Vertical sidebar containing project information: CITY OF ROCHESTER, PORTLAND AVENUE REVITALIZATION, GENERAL NOTES, LEGEND, AND INDEX, copyright notice, and drawing title GN-1.

PORTLAND AVENUE REVITALIZATION PROJECT
 CITY OF ROCHESTER
 MONROE COUNTY, STATE OF NEW YORK

CITY OF ROCHESTER, NEW YORK
PORTLAND AVENUE REVITALIZATION
CONSTRUCTION DETAILS

TYPICAL SECTION - PROPOSED

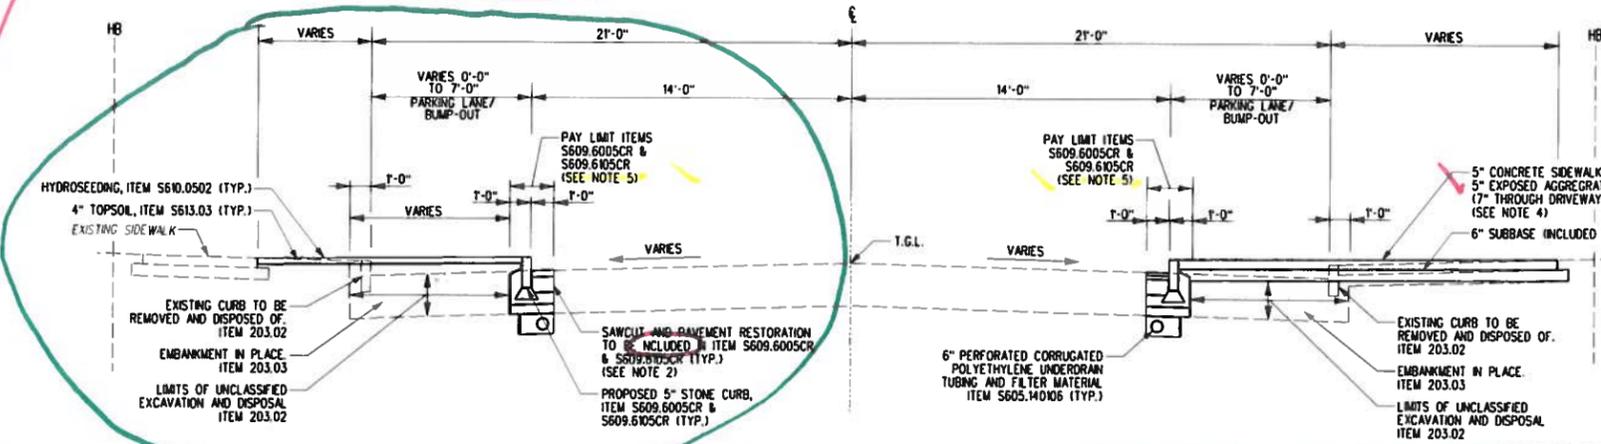
can they fit under any of the existing sections?

TYPICAL SECTION - PROPOSED

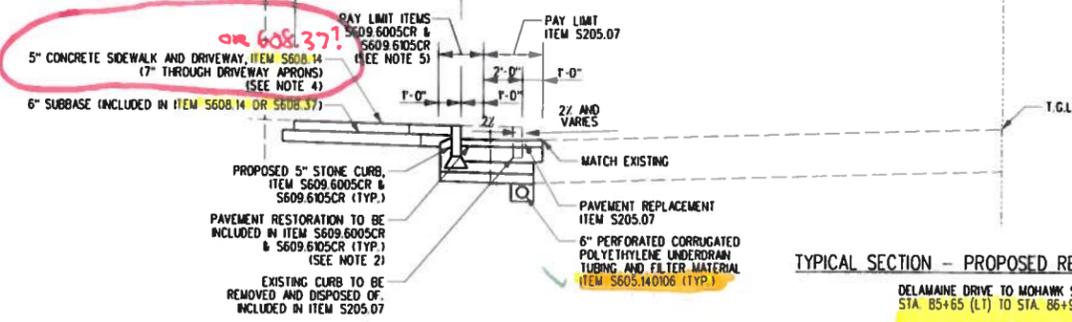
TYPICAL SECTIONS DO NOT MATCH PLAN VIEWS!

WATER SERVICE TAP EXCAVATION DETAIL
NOT TO SCALE
STD DWG NO. _____
LAST REVISED _____

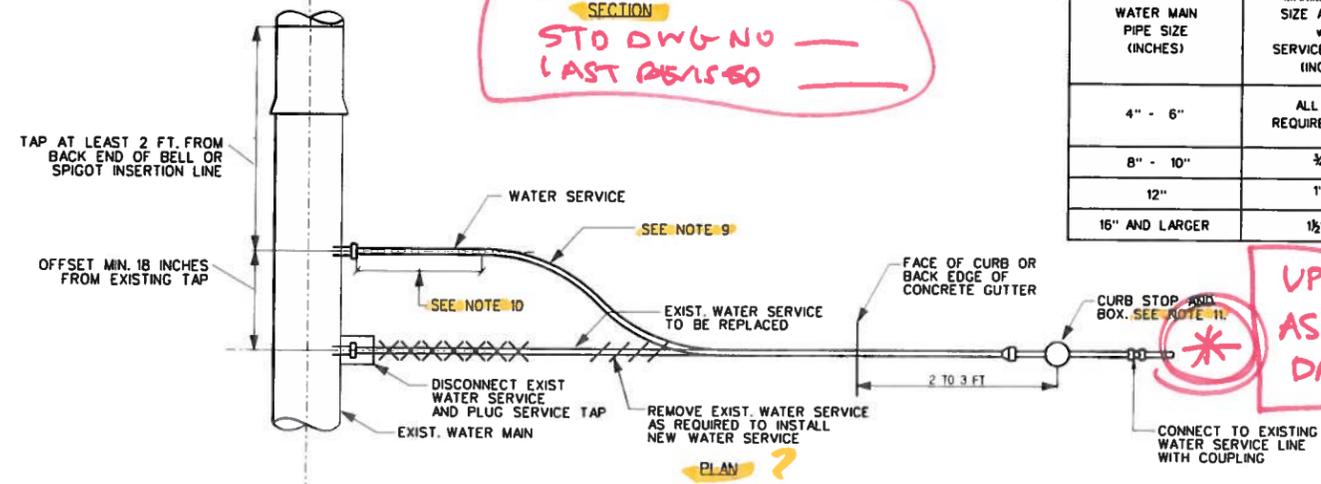
SECTION
STD DWG NO. _____
LAST REVISED _____

*** UPDATE DETAILS AS NOTED IN EMAIL DATED 2/20/15 (PAT O'CONNOR)**

WATER SERVICE PIPE 2" DIAMETER AND SMALLER DETAIL
NOT TO SCALE
STD DWG NO. _____
LAST REVISED _____

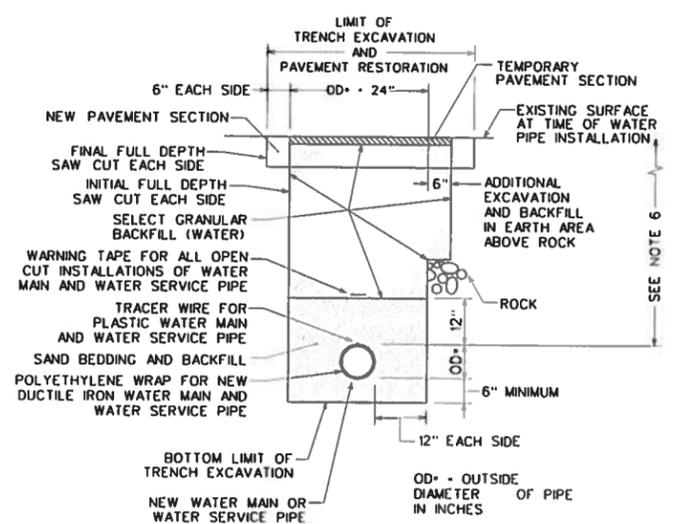
not part of the detail!

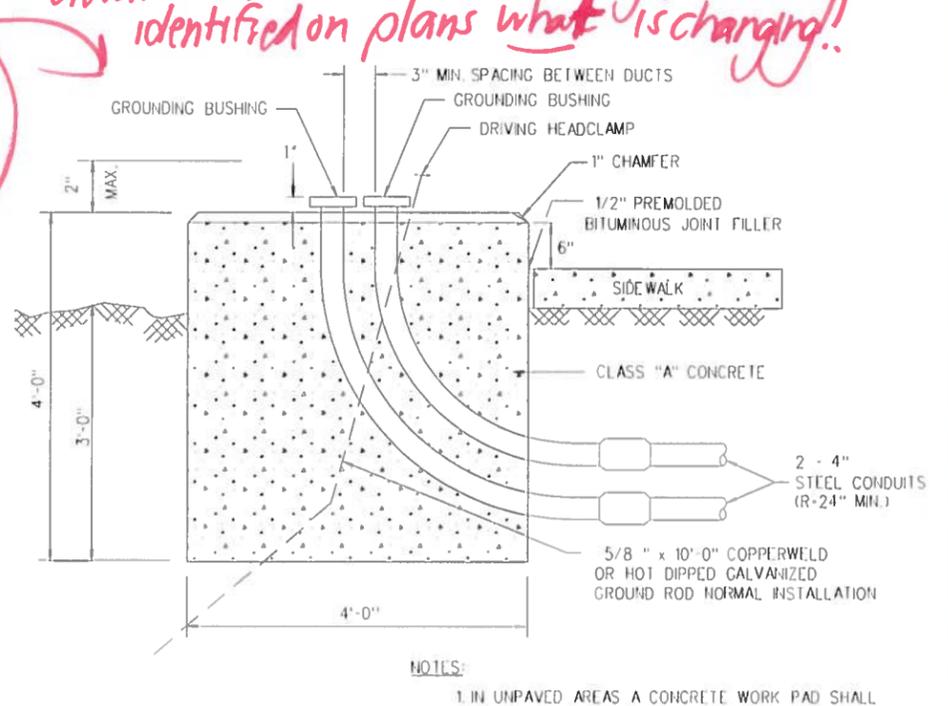
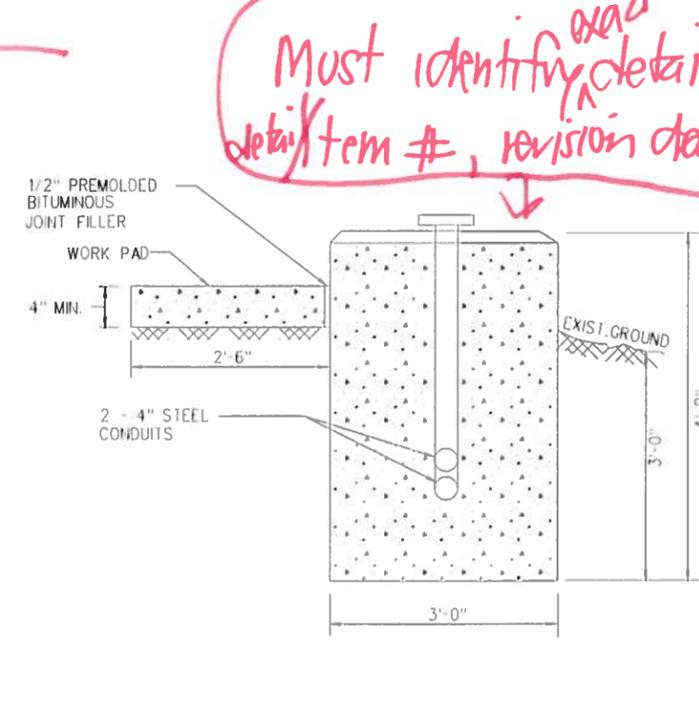
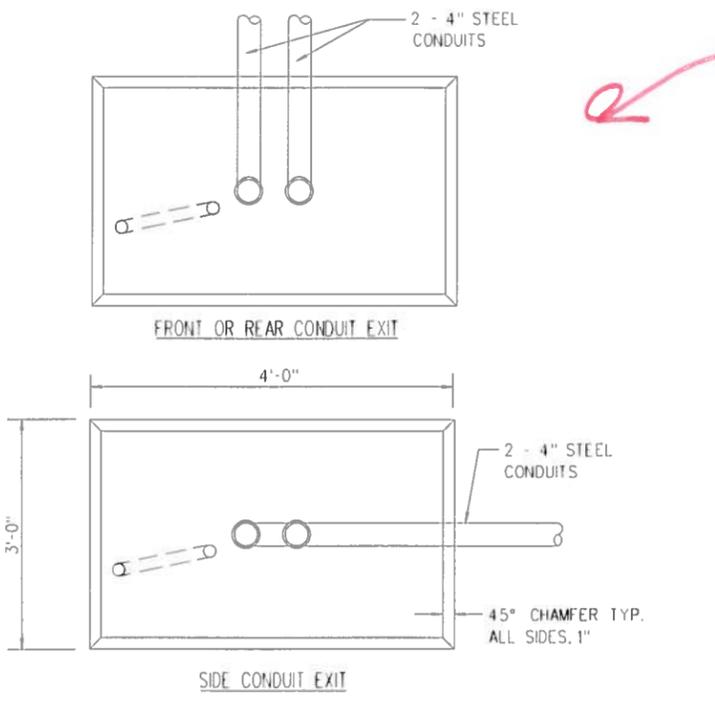
Must identify exact detail name, detail item #, revision date / issue date!

details must not be changed unless identified on plans what is changing!

Where did this detail come from??

Where did detail come from??

Where did detail come from??

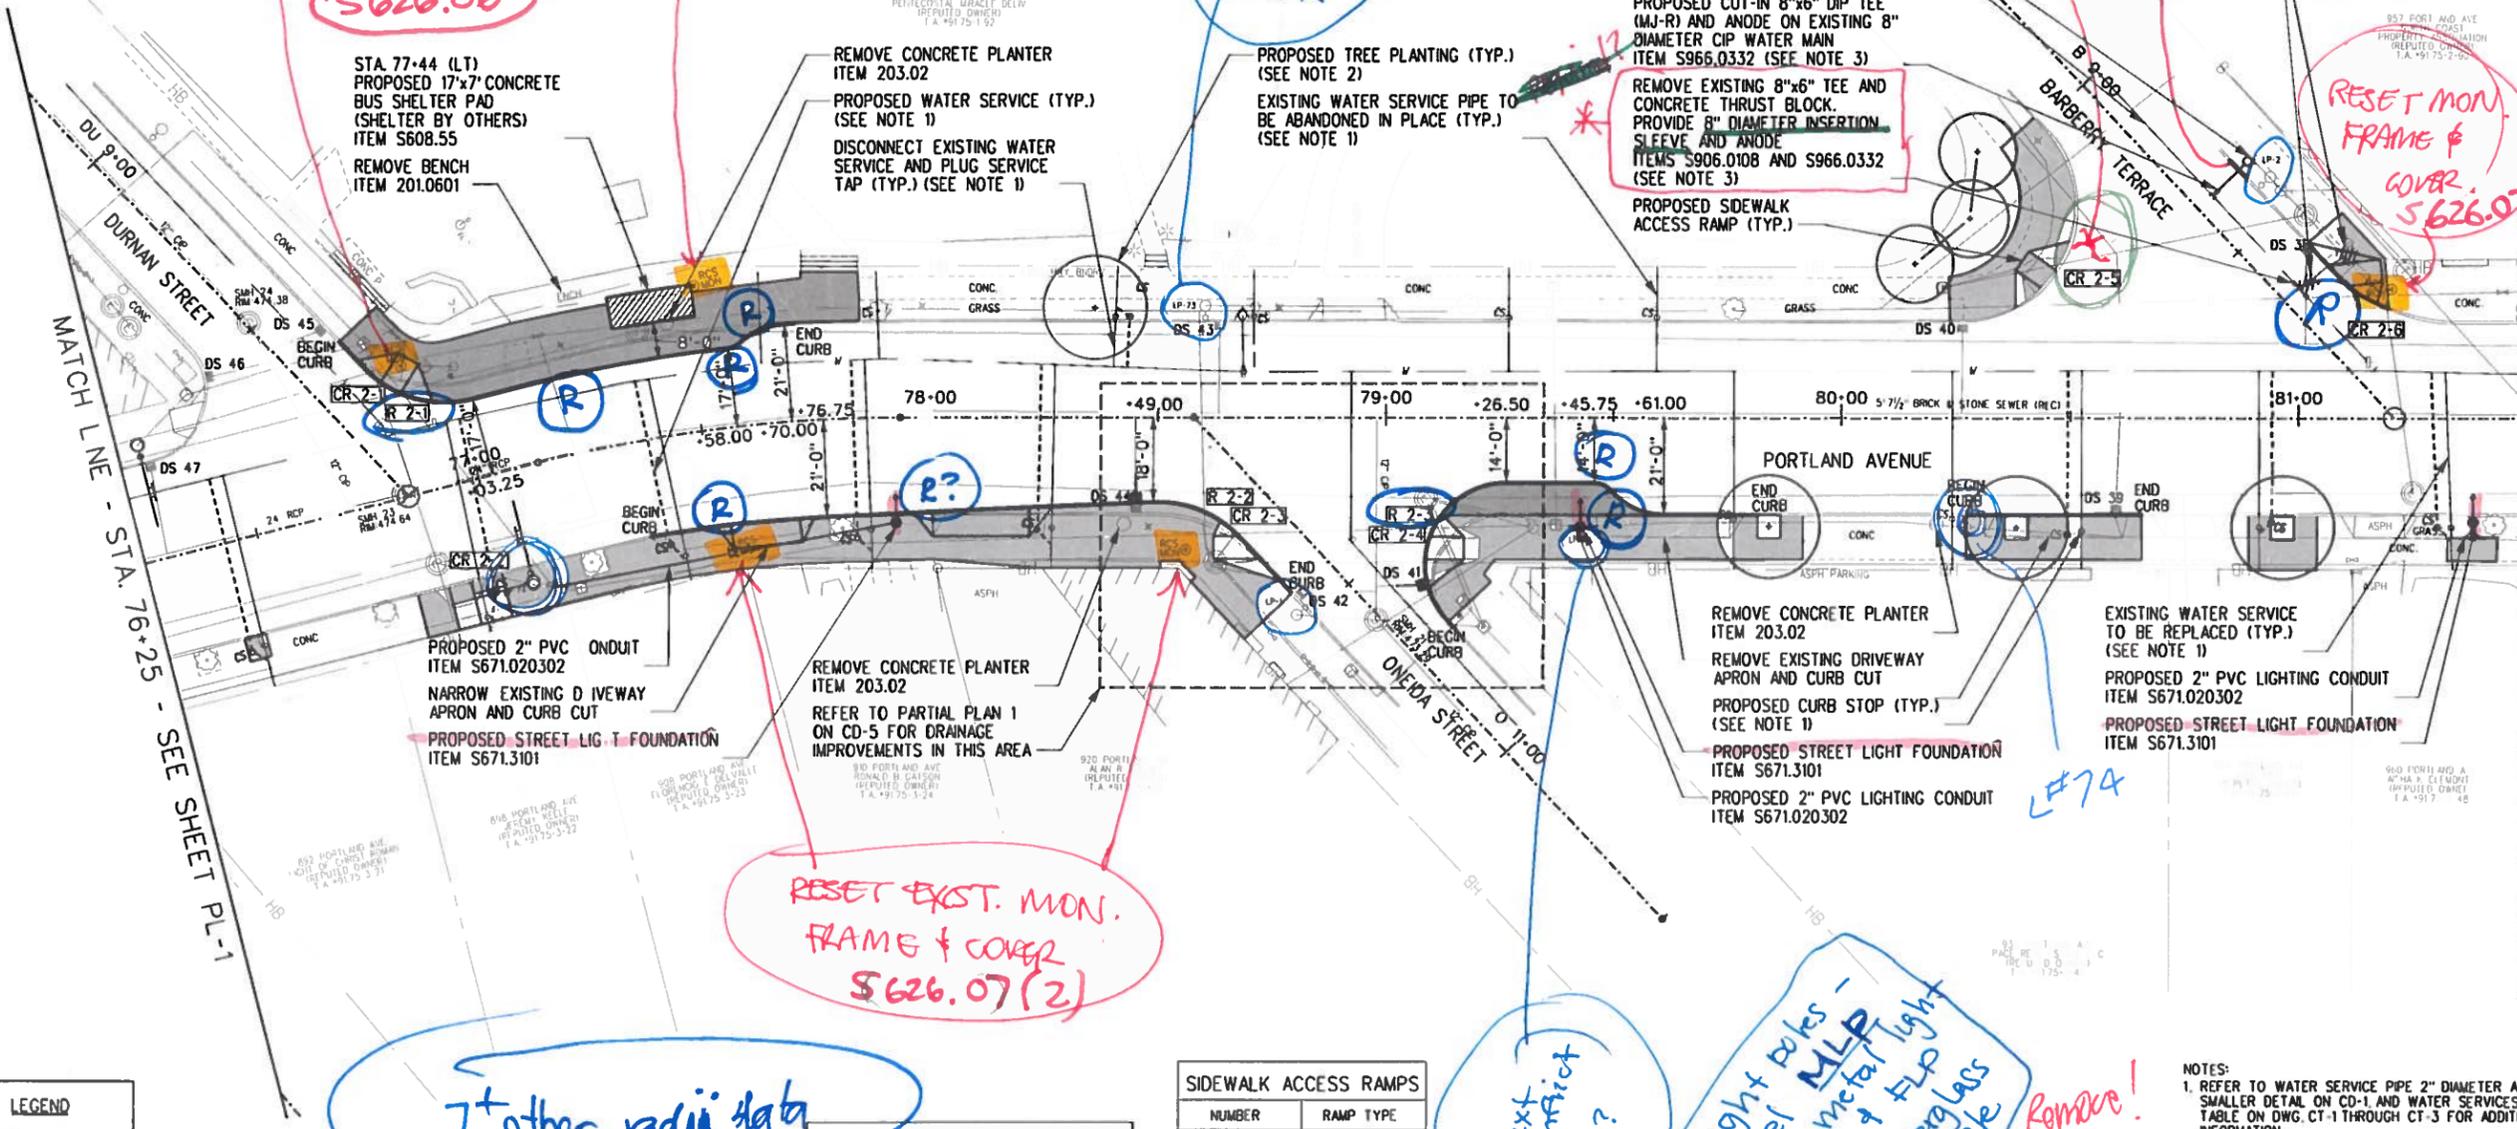
Text conflict LP?

Light poles - label MLP for metal light pole & FL0 light pole

new pole base? why is it labeled with existing LP label?

CITY OF ROCHESTER, NEW YORK
 PORTLAND AVENUE REVITALIZATION
 ROADWAY PLAN

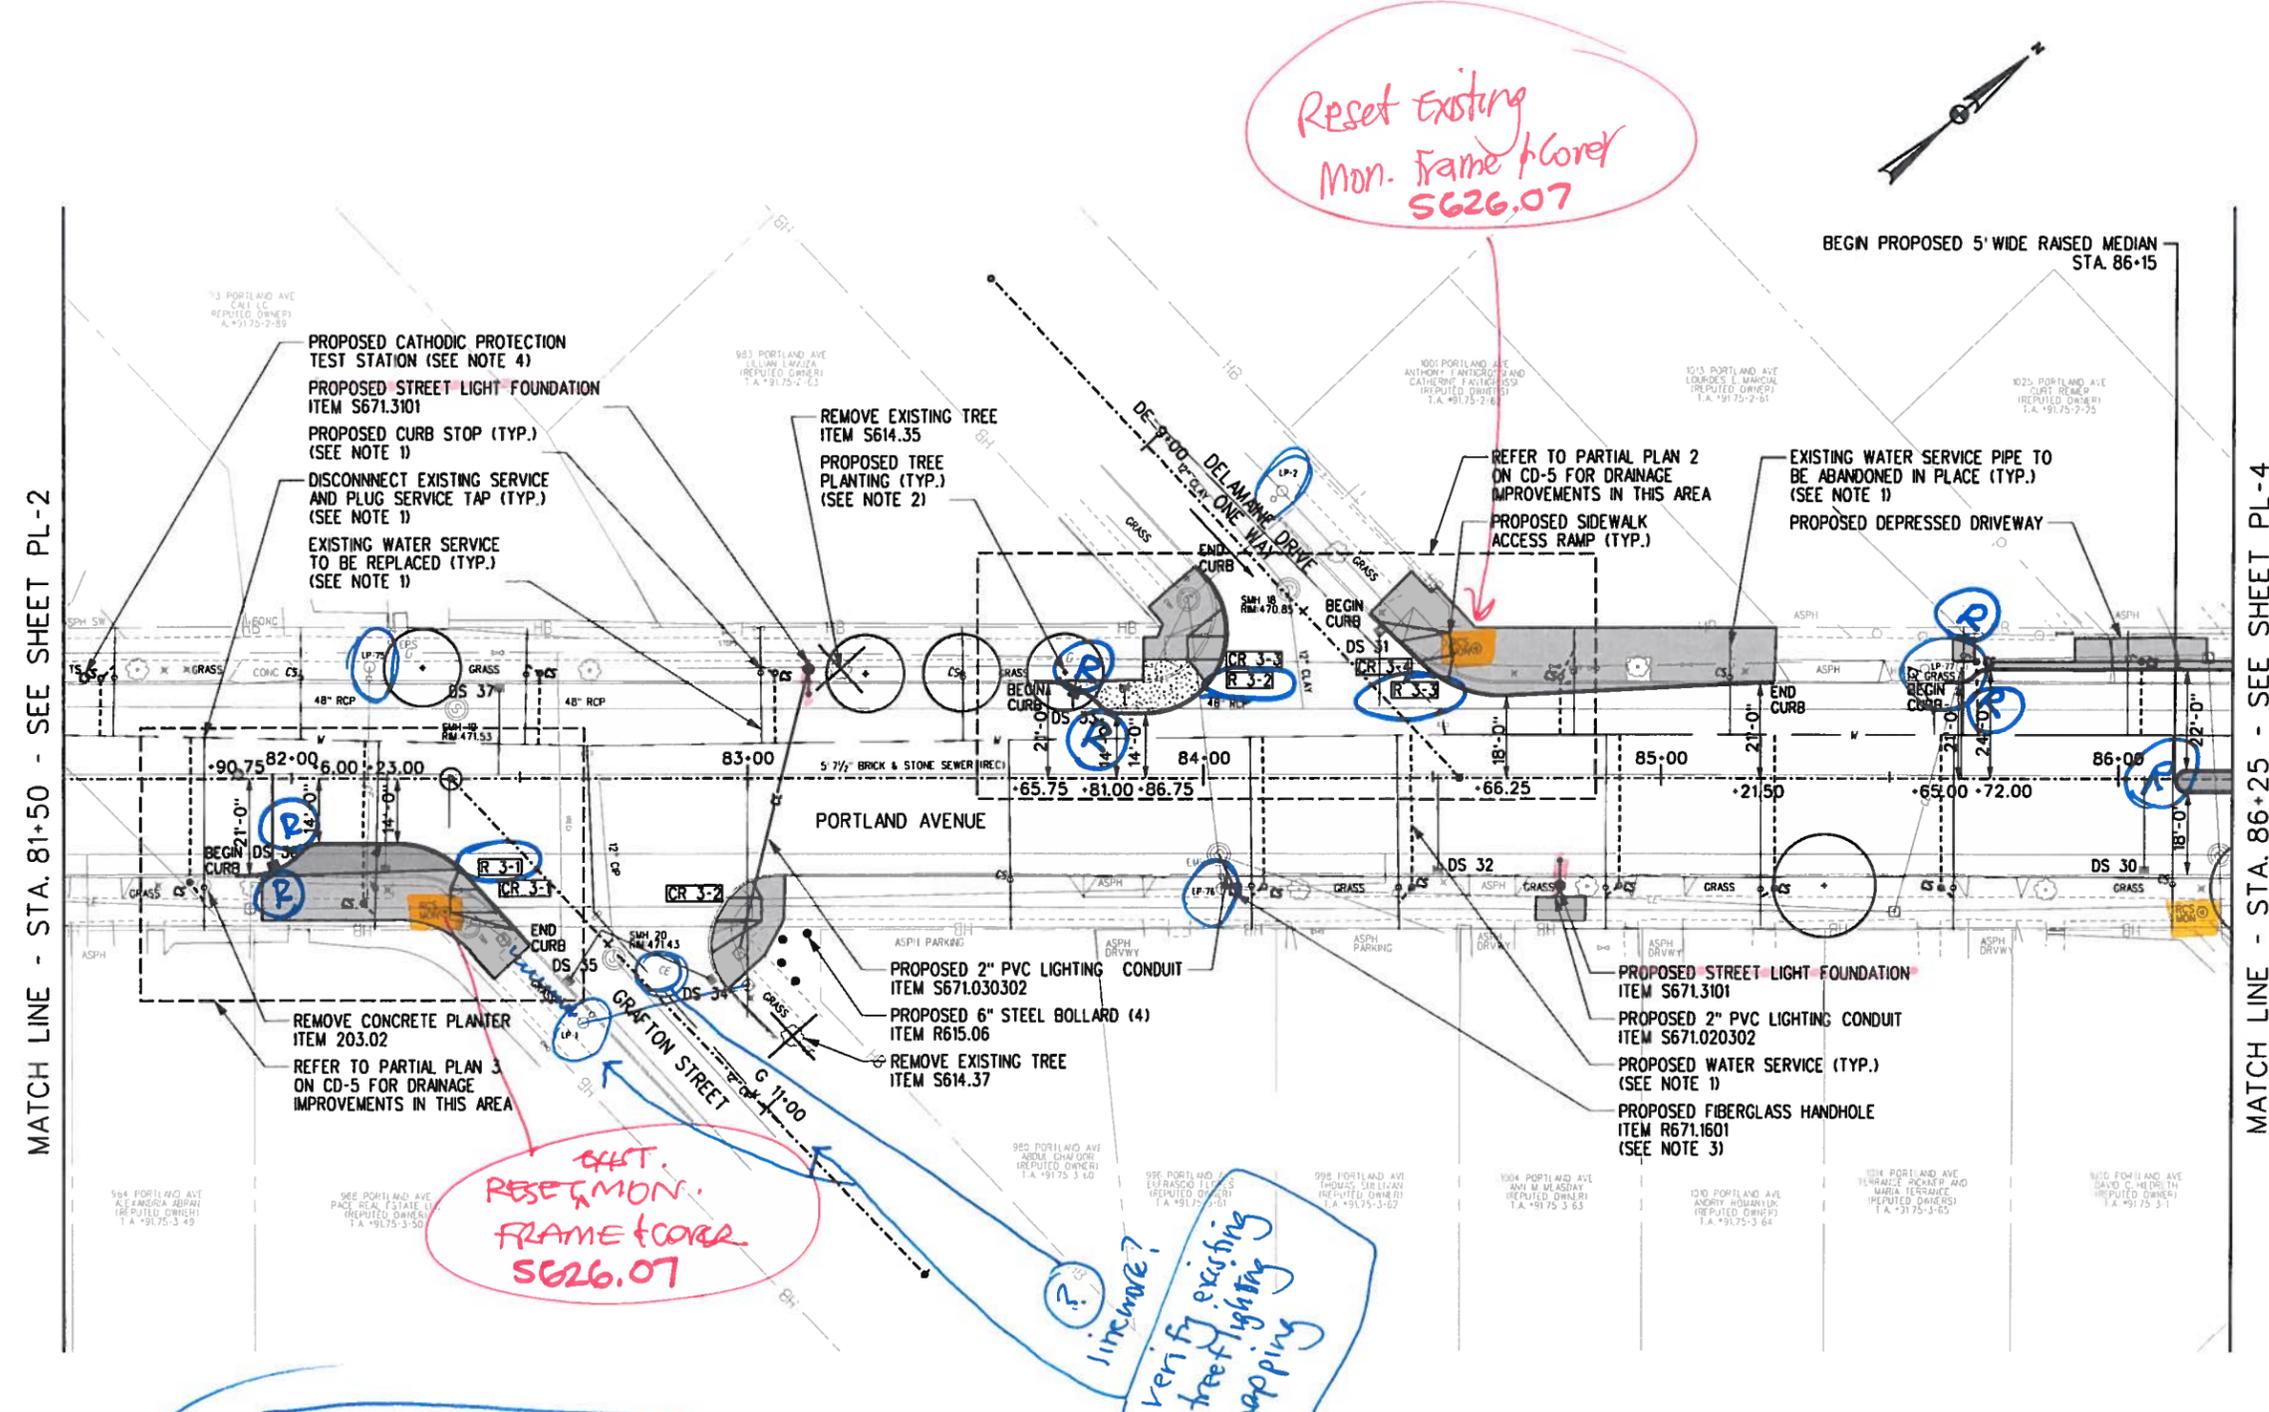
*verify existing
 street lighting
 mapping*
